PROJECT: THE WORLD TRADE CENTER | TITLE: STEEL BEAM REPAIR AT EL. 310 - ZONE K-5 | DATE: 1-15-71

Part Plan at El. 310 - Zone K-5

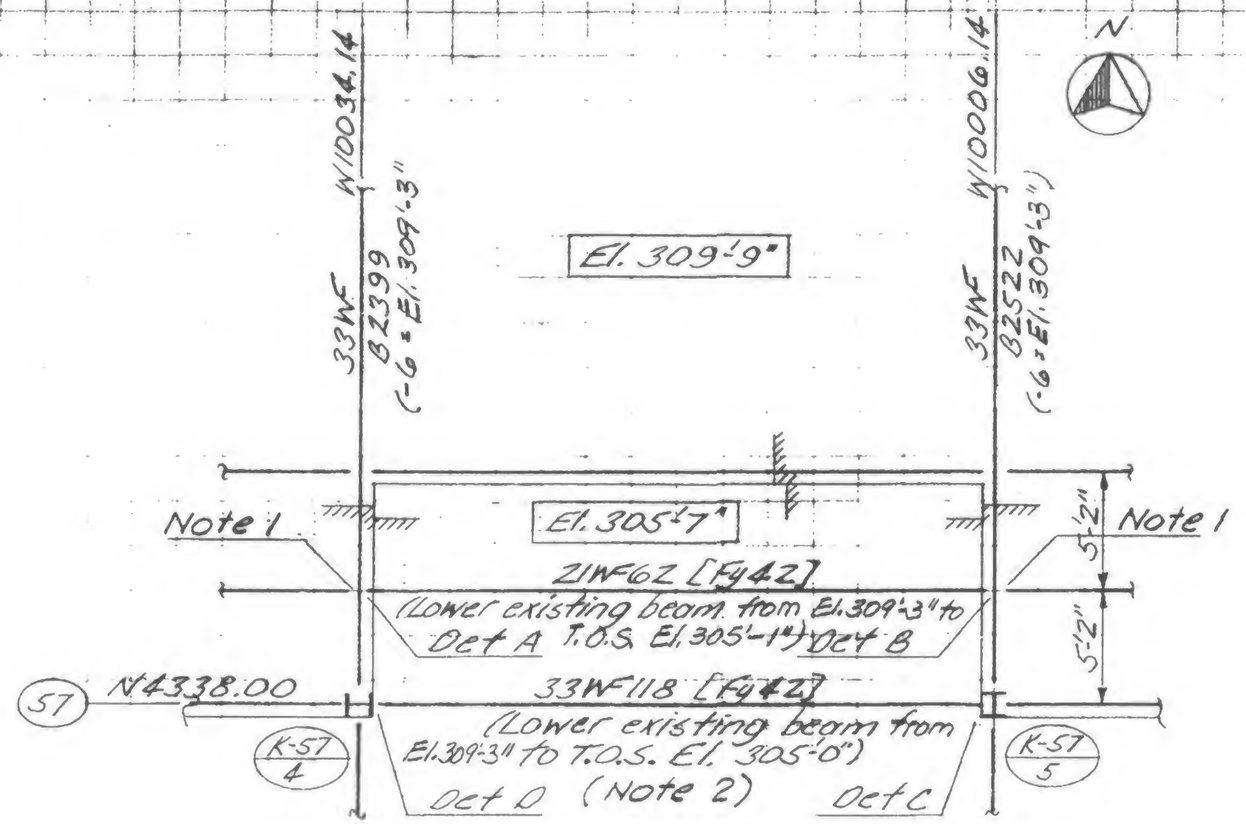
1. Before unbolting provide adequate temporary support to these beams and reconnect after beam between has been lowered.
2. Remove exist. connection fittings after beam has been lowered.
